Final Technical Staff Report

***Nitrogen Loads from Wastewater Flowing to Malibu Lagoon are a
Significant Source of Impairment to Aquatic Life***

Subject: **Peer Review Response to Comments - Technical Memorandum #4: Nitrogen Loads from Wastewater Flowing to Malibu Lagoon are a Significant Source of Impairment to Aquatic Life**

Figure 5 Nitrogen concentrations in Lagoon water resulting from different mass loadings entering the Lagoon

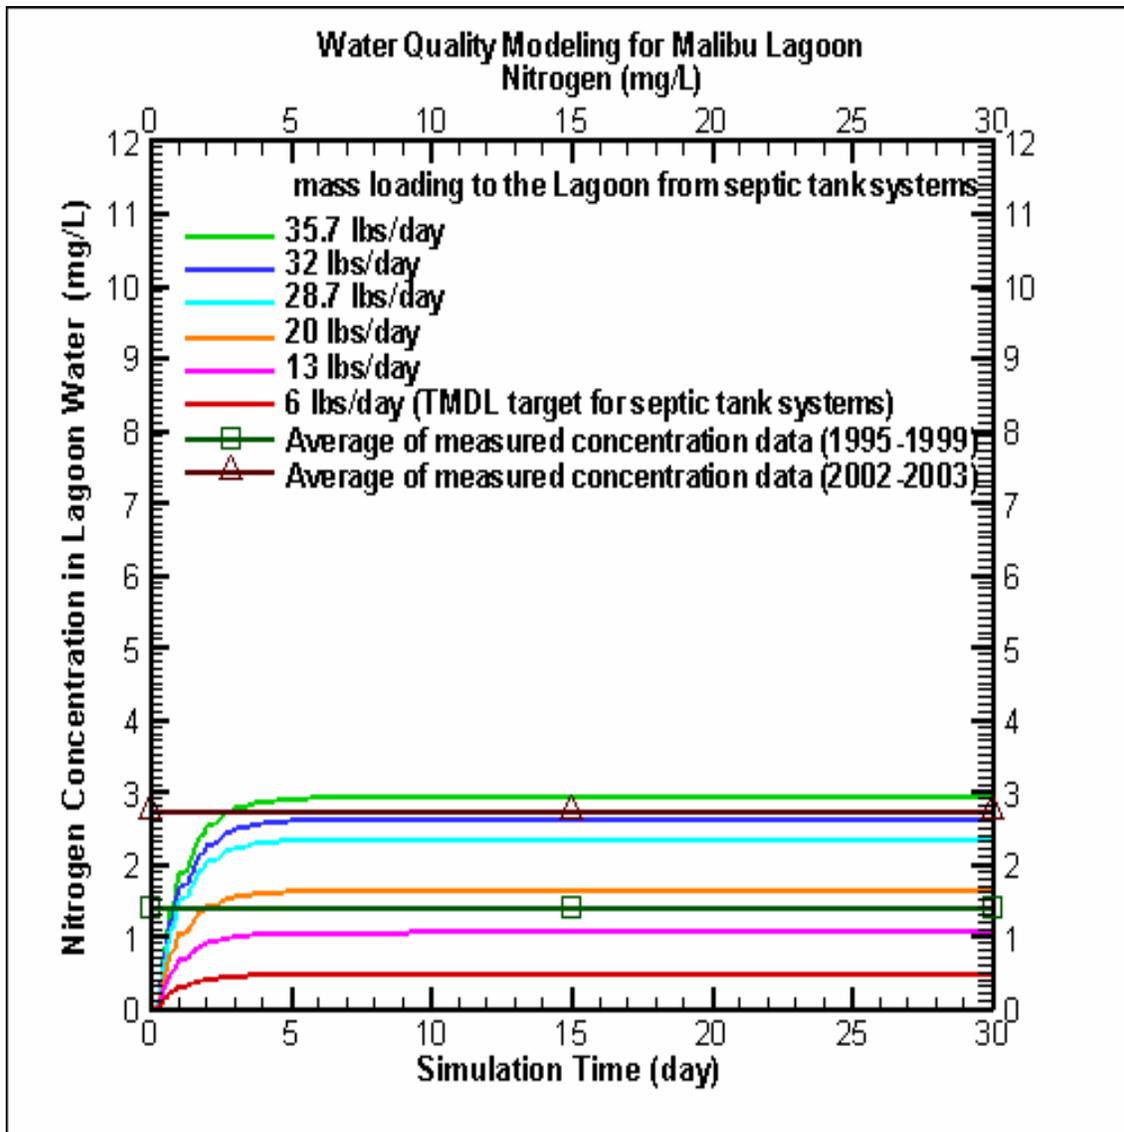
Although it goes beyond the limits of my review, I would like to know how much 6 lbs/day of nitrogen addition to the lagoon is likely to increase available nitrogen levels in Malibu Lagoon. To that end, what would be the incremental change in total nitrogen concentration in effluent from the Malibu Creek due to 6 lbs/day (as N) of supplemental nitrogen under some sort of critical flow condition?

An evaluation of nitrogen mass loading in Malibu Lagoon is given in Attachment 4-1 (by Dr. Lai) of Tech Memo #4. Figure 5 of Attachment 4-1 indicates that, assuming no other sources exist, a 6 lbs/day of total nitrogen load into the lagoon would bring the nitrogen concentration in the water from 0 to approximately 0.5 mg/L.
